Memorandum

To	Le' Ann Whitehouse Seely, OALA, CSLA	Page	1
CC	Jana Joyce Associate, MBTW Group		
Subject	Gore Park Pedestrianization: Grading Review		
From	Ian Izzard, P.Eng., M.A.Sc. Project Manager		
Date	May 17, 2012	Project Number	60225470

Memorandum

To	Jana Joyce, MBTW-Watchhorn	Page	1 of 4
CC			
Subject	Gore Park Utility review		
From	Ian Izzard		
Date	September 06, 2012	Project Number	60225470

KING STREET EAST
GORE PARK PEDESTRIANIZATION
GRADING REVIEW
CENTRAL GARDEN CROSS SECTION
From : James Street South
To : Hughson Street South

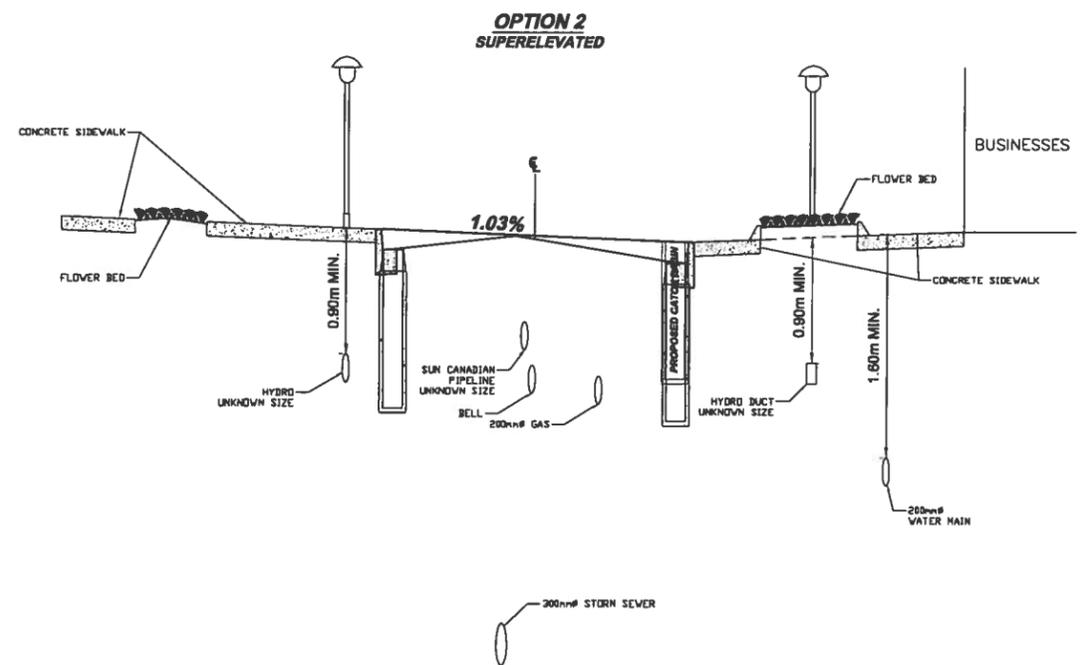
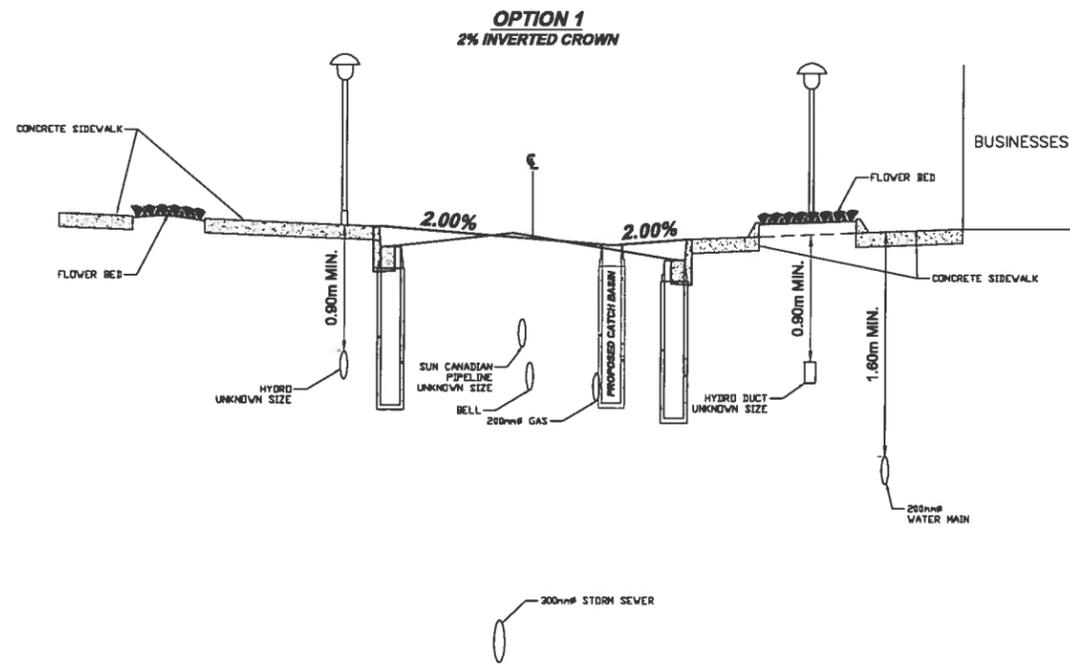
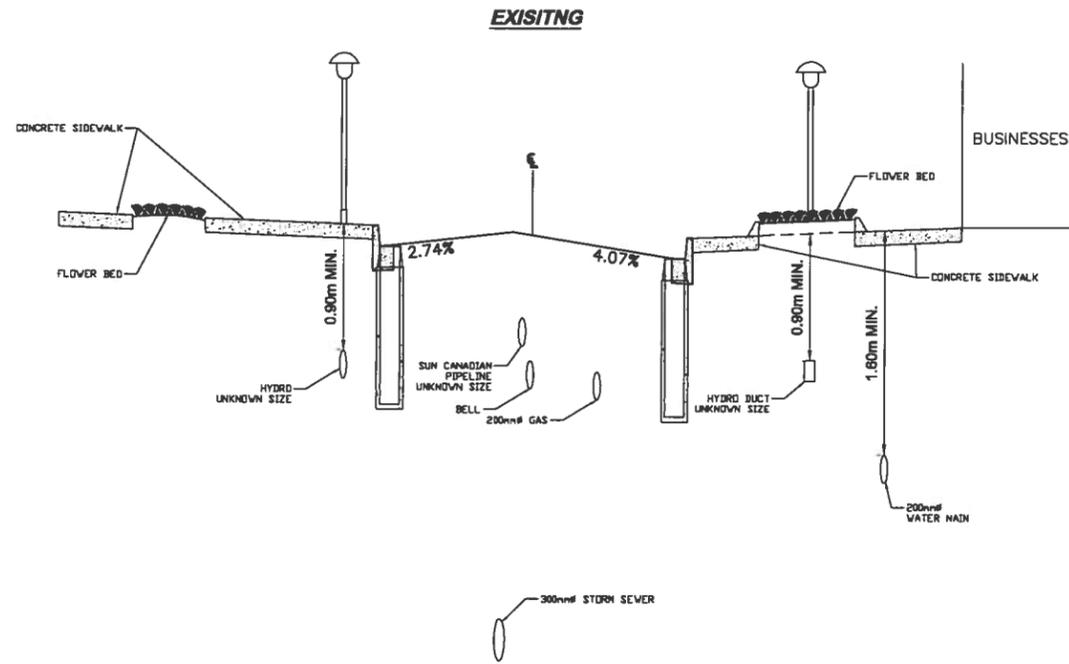
Central Garden Block;

This section of the park runs from James Street to Hughson Street. The existing roadway is built with a crown of approximately 2% to the north and 4% to the south. There is a 150mm gutter on either side of the street. Two options were reviewed for the Pedestrianization of this block

Inverted crown	Full cross slope
Pedestrianization	Proposed road surface is flush with the existing sidewalk and curb	Proposed road surface is flush with the existing sidewalk and curb
Sub drains	New sub drain will have to be installed under the low point in the road to ensure drainage of the stone base under the road.	Roadway sub drain will remain in its present location and will ensure drainage of the stone base under the road.
Cross slope	2% cross fall as per City standards	1% cross fall, does not meet City standards
Water storage	Water storage from heavy storm may back-up within the existing roadway before it approaches the building.	Water storage from heavy storm may back-up on the sidewalk and approach the existing buildings.
Catch basins	Existing catch basins will be removed and replaced with new catch basins at the low point in the roadway.	Existing catch basins can remain in their existing location and be raised to the elevation of the proposed Pedestrianized road. Additional catch basins will be required between the existing catch basins.

KING STREET EAST
CORE PARK PEDESTRIANIZATION
GRADING REVIEW
VETERANS PLACE CROSS SECTION
From : Hughson Street South
To : John Street South

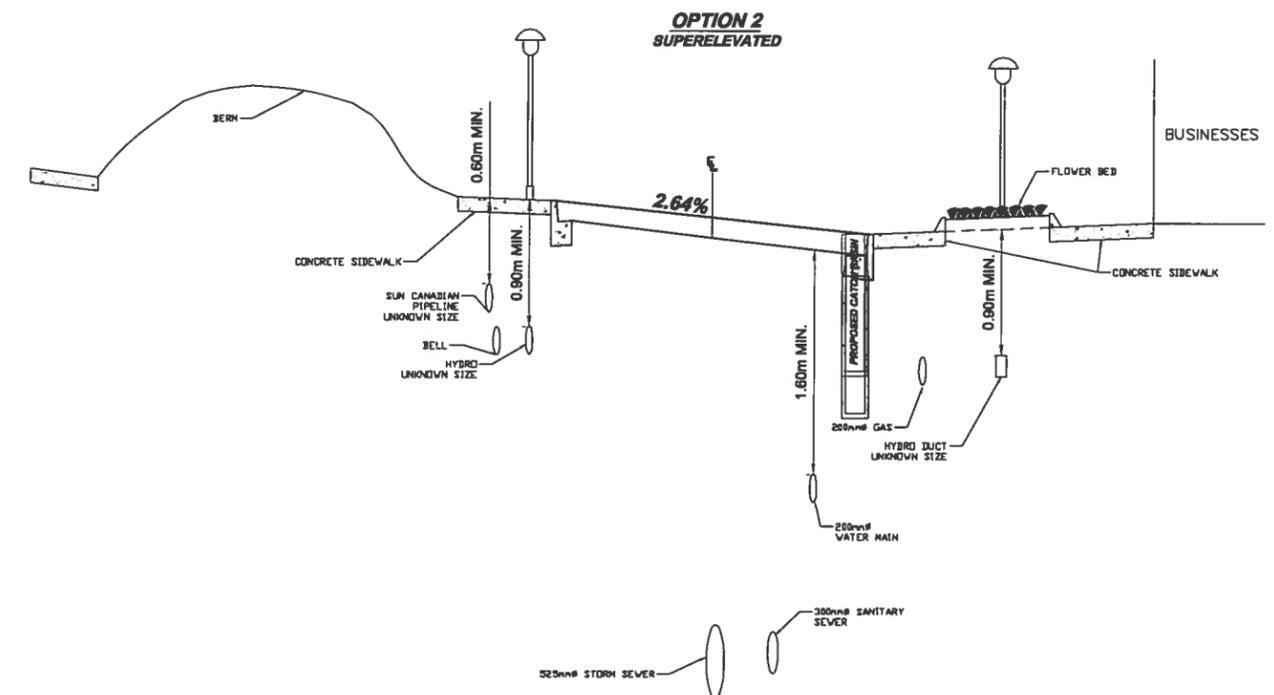
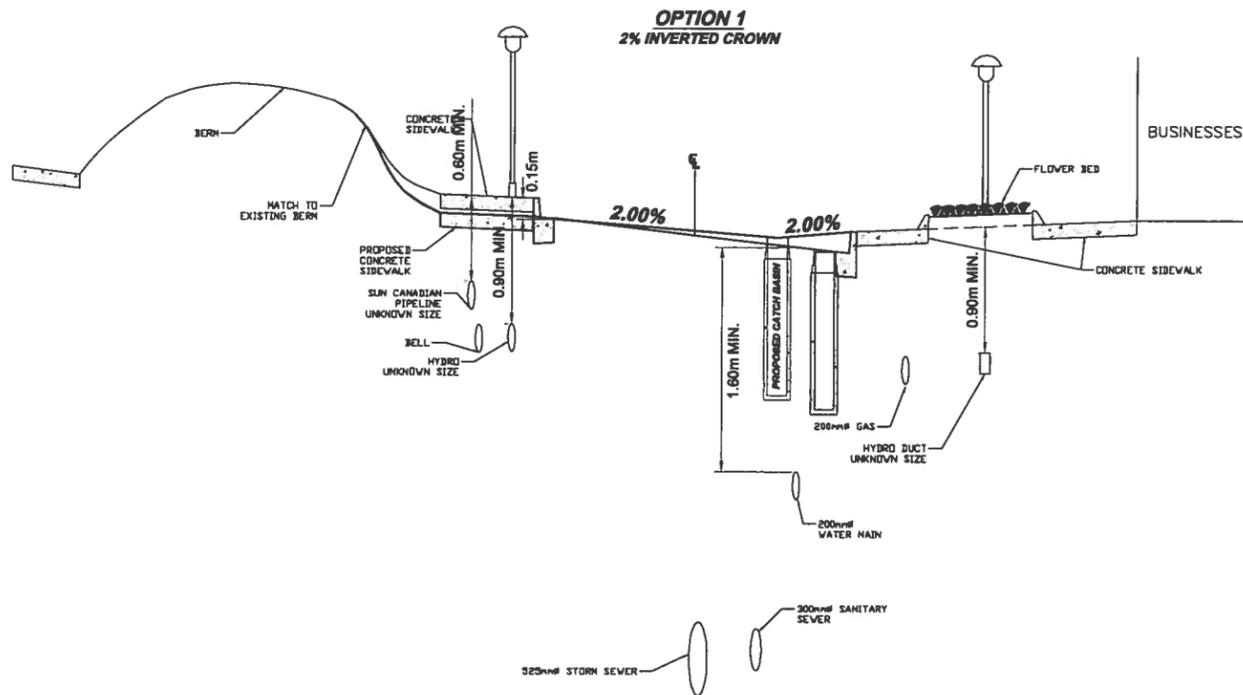
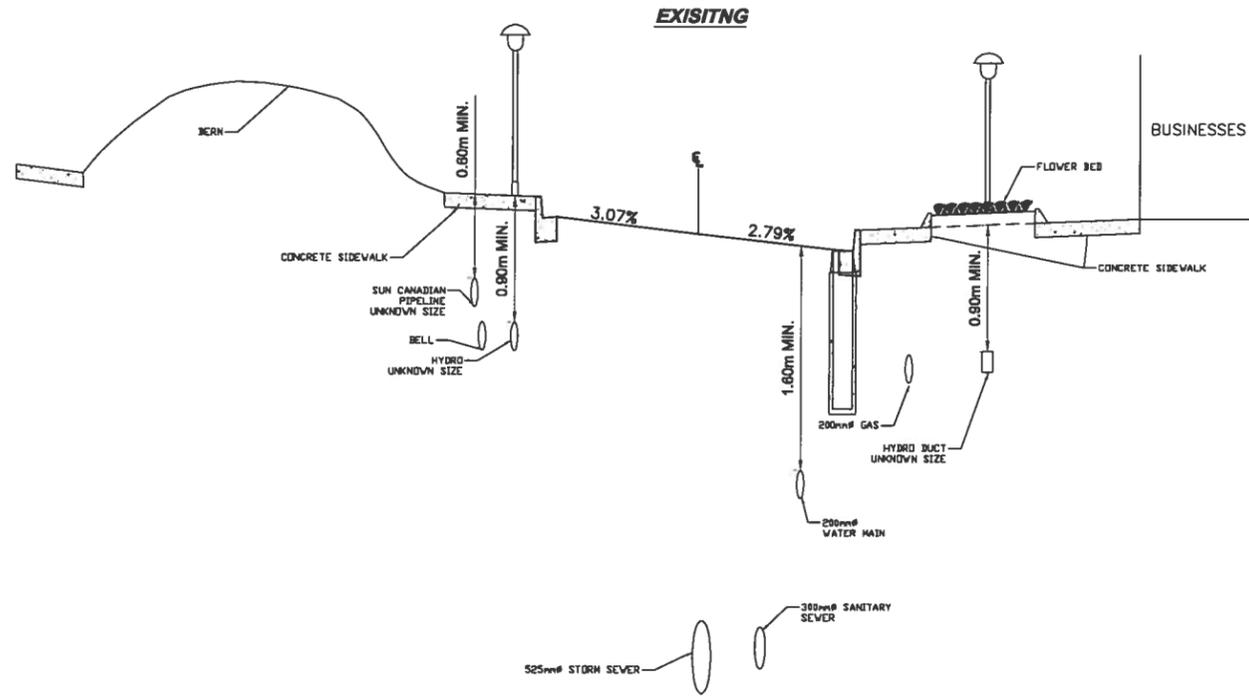
Veteran’s Place:

This section of the park runs from Hughson Street to John Street. The existing roadway is built with a cross slope of approximately 2% to the south. There is a 150mm gutter on either side of the street. Two options were reviewed for the Pedestrianization of this block

Inverted crown	Full cross slope
Pedestrianization	Proposed road surface is flush with the existing sidewalk. The north side curb will have to be lowered approximately 150mm to match the proposed slope. This additional depth will be accommodated in the proposed park renovations.	Proposed road surface is flush with the existing sidewalk and curb
Sub drains	New sub drain will have to be installed under the low point in the road to ensure drainage of the stone base under the road.	Roadway sub drain will remain in its present location and will ensure drainage of the stone base under the road.
Cross slope	2% cross fall as per City standards	2.6% cross fall, exceeds City standards but is acceptable
Water storage	Water storage from heavy storm may back-up within the existing roadway before it approaches the building.	Water storage from heavy storm may back-up on the sidewalk and approach the existing buildings.

Catch basins	Existing catch basins will be removed and replaced with new catch basins at the low point in the roadway.	Existing catch basins can remain in their existing location and be raised to the elevation of the proposed Pedestrianized road. Additional catch basins will be required between the existing catch basins.

KING STREET EAST
GORE PARK PEDESTRIANIZATION
GRADING REVIEW
MACDONALD SQUARE CROSS SECTION
From : John Street South
To : Catharine Street South

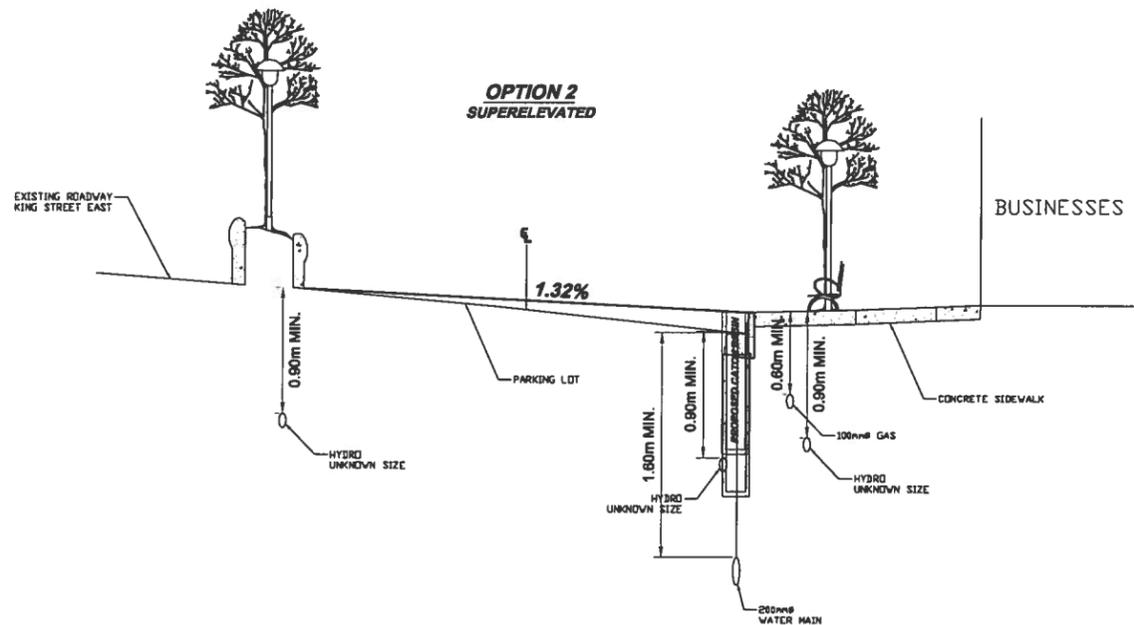
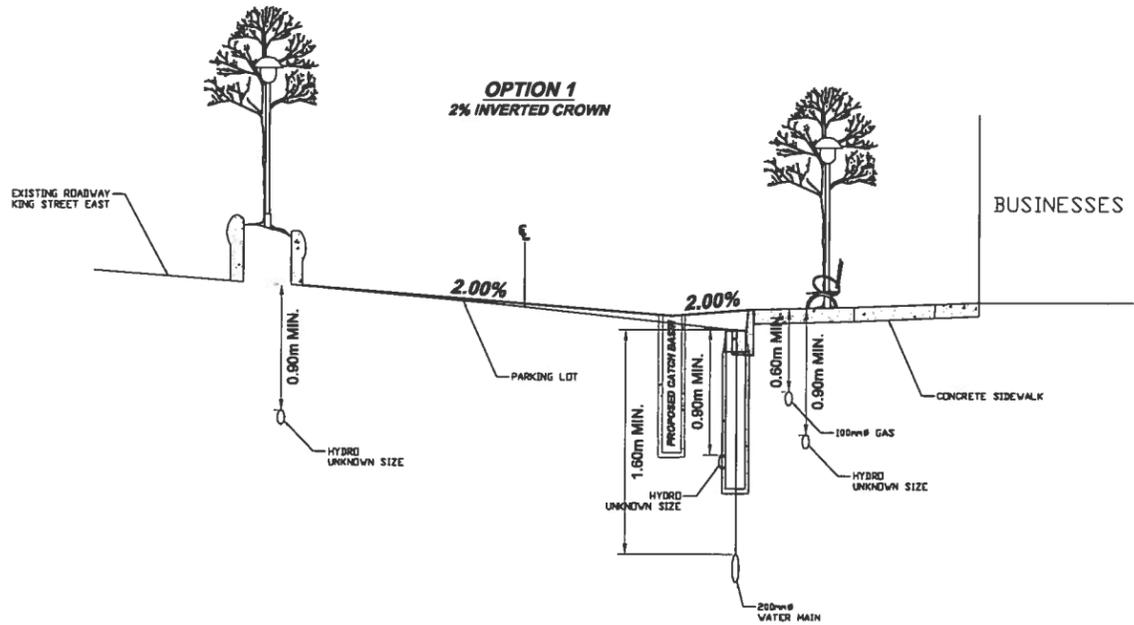
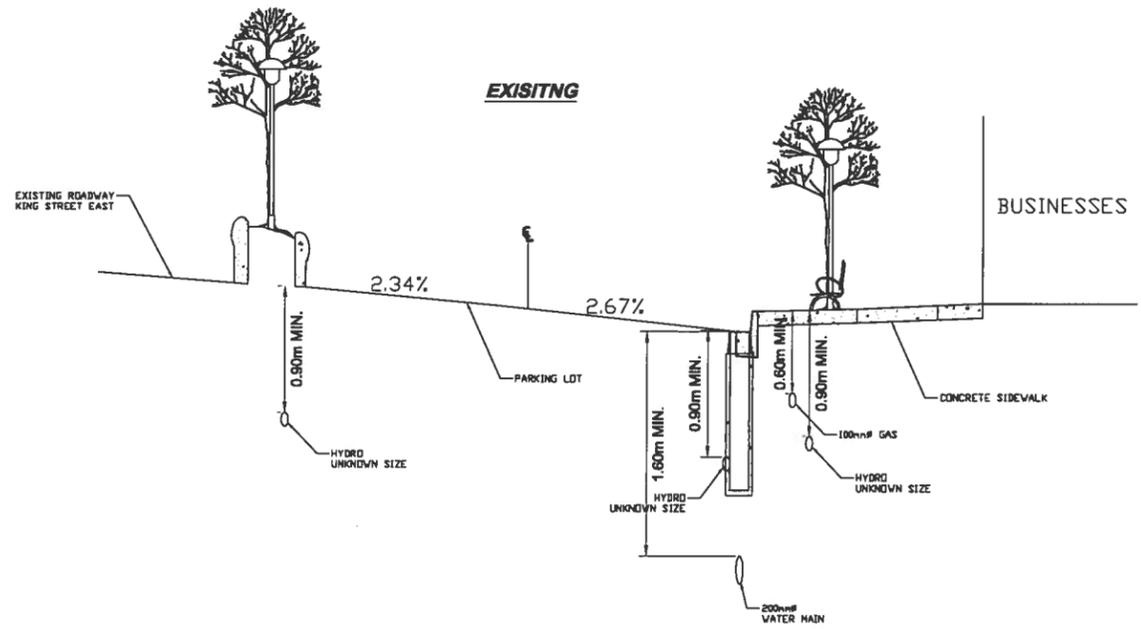
MacDonald Square:

This section of the park runs from John Street to Catharine Street. The existing roadway is built with a cross slope of approximately 2.5% to the south. There is a 150mm gutter on the south side of the street; the North side of the rolling surface is flush with king Street. Two options were reviewed for the Pedestrianization of this block:

Inverted crown	Full cross slope
Pedestrianization	Proposed road surface is flush with the existing sidewalk and curb	Proposed road surface is flush with the existing sidewalk and curb
Sub drains	New sub drain will have to be installed under the low point in the road to ensure drainage of the stone base under the road.	Roadway sub drain will remain in its present location and will ensure drainage of the stone base under the road.
Cross slope	2% cross fall as per City standards	1.3% cross fall, does not meet City standards
Water storage	Water storage from heavy storm may back-up within the existing roadway before it approaches the building.	Water storage from heavy storm may back-up on the sidewalk and approach the existing buildings.
Catch basins	Existing catch basins will be removed and replaced with new catch basins at the low point in the roadway.	Existing catch basins can remain in their existing location and be raised to the elevation of the proposed Pedestrianized road. Additional catch basins will be required between the existing catch basins.
